Project Amendments  
BLD2021-03082  
APN 037-333-200  
130 Bridgeport Dr.  
Half Moon Bay, CA 94019

## SUMMARY OF CHANGES

November 2, 2023

**3 EXTERIOR VIEW**  
scale: NTS

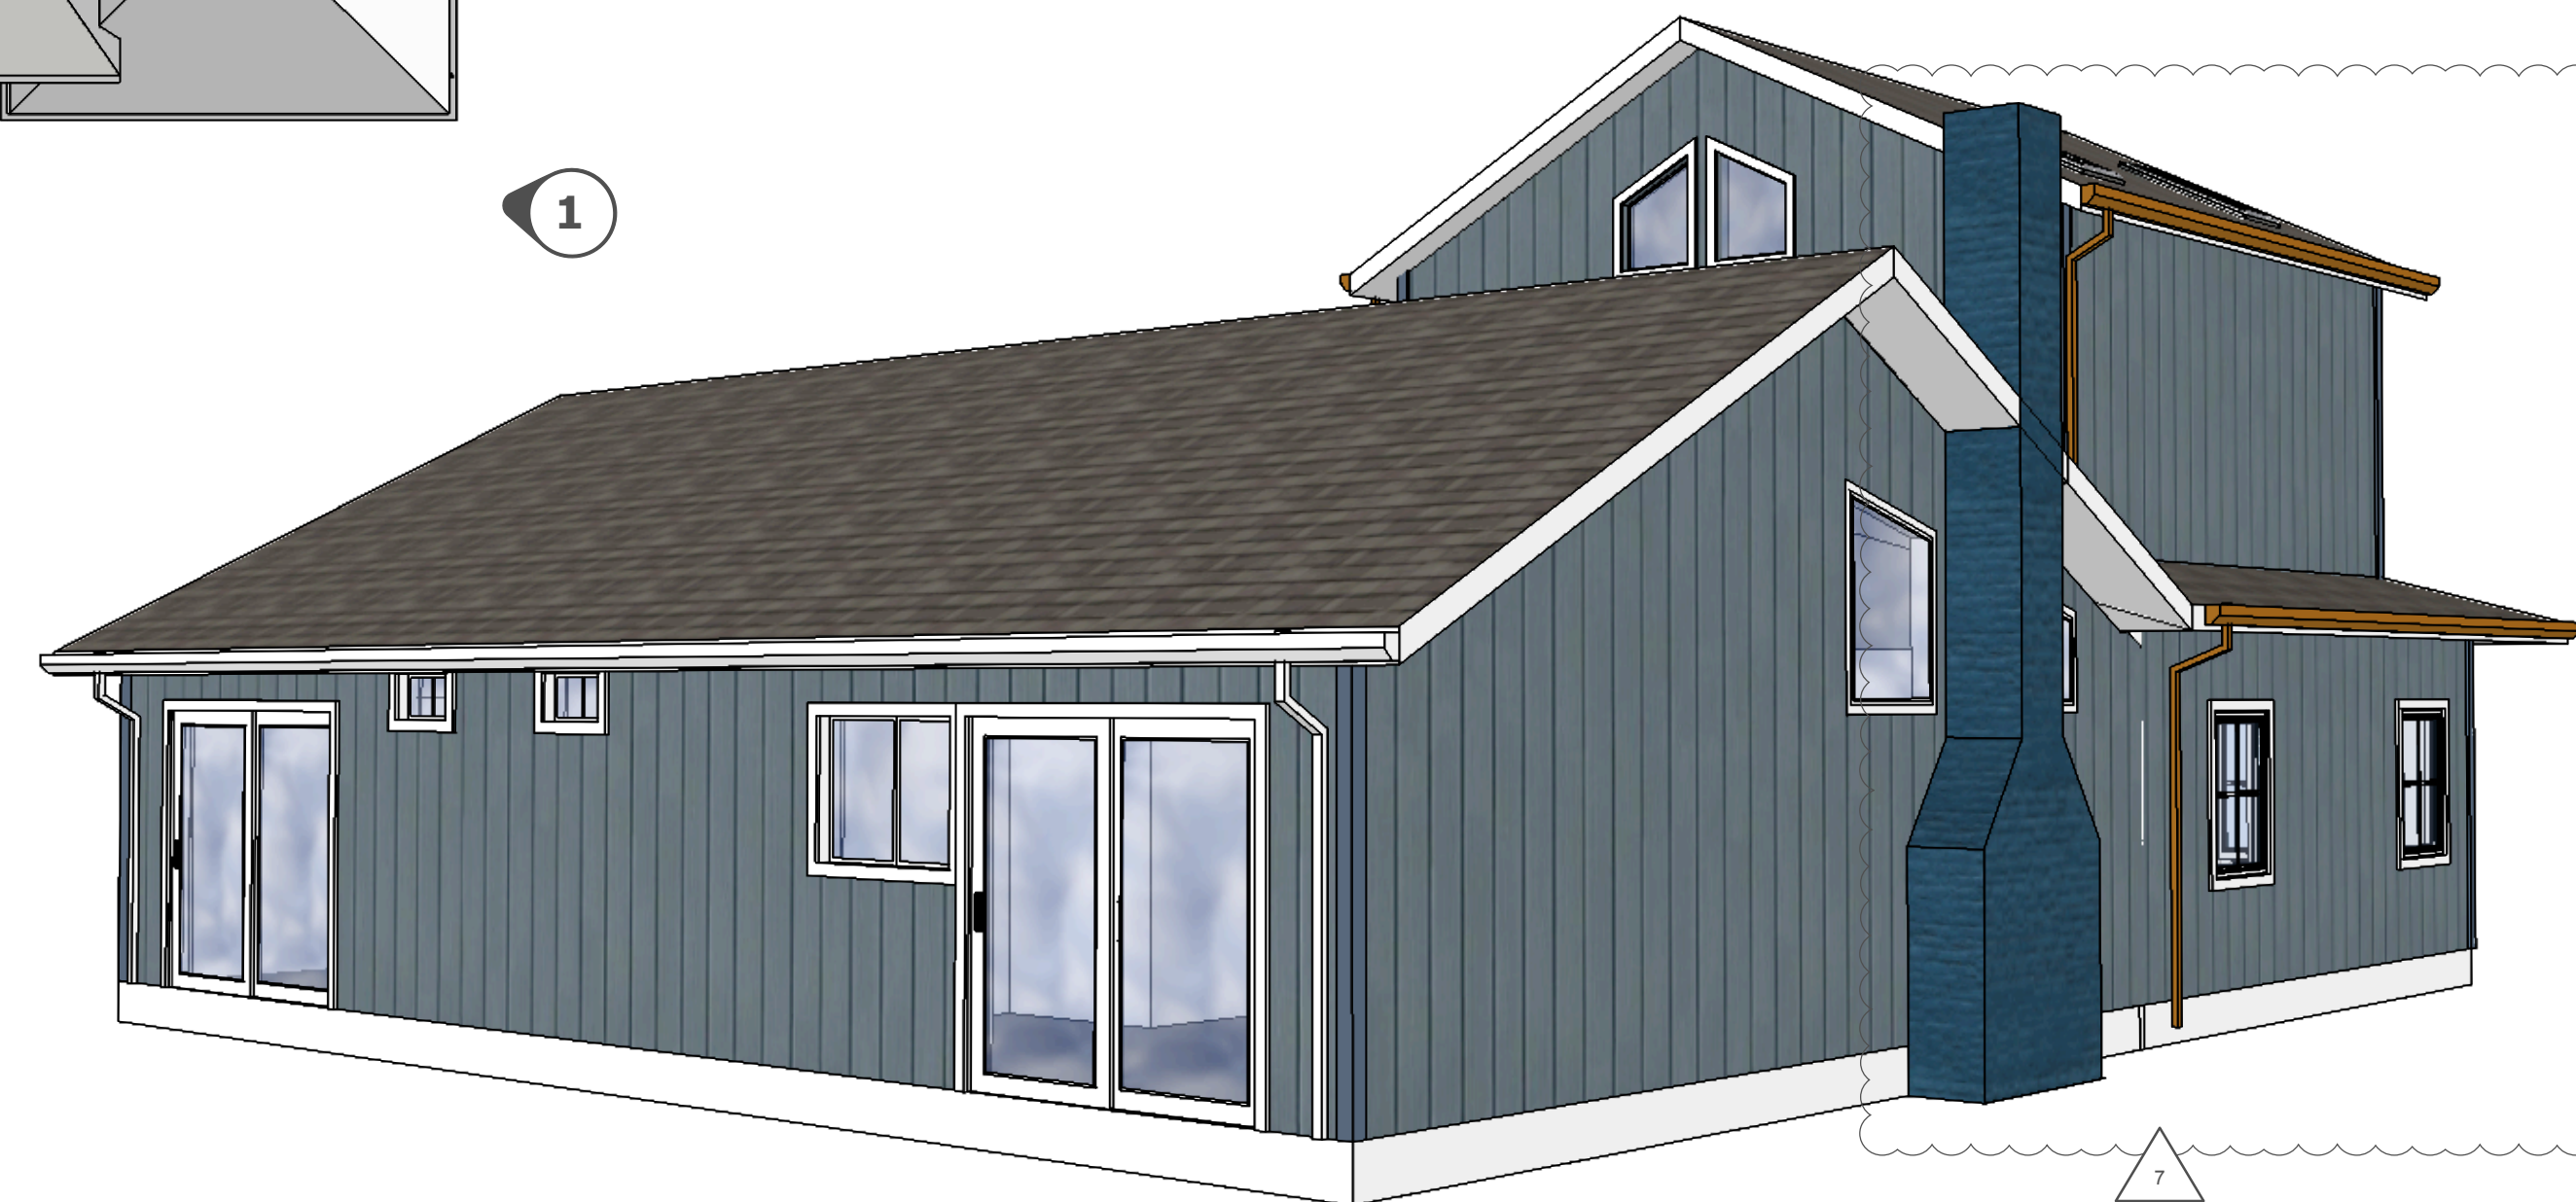
The second proposed change is our paint plan, roof color, and gutters. These changes are noted on pages A1.01, A3.02, A8.02 Color/Material Board and Statement of Compliance – DR STDS. The approved color was Newburyport Blue for the siding and Extra White for the trim and fascia. The colors we chose are Benjamin Moore Blue Note for the siding, which is grayer than Newburyport Blue but is very similar. For the trim and fascia, we chose Benjamin Moore Classic Gray, which is considered an off-white, as you can see in the Color/Material Board on page A8.02. After design consultation and research, we chose an off-white for the trim because a true white would be too bright in contrast to the blue siding.
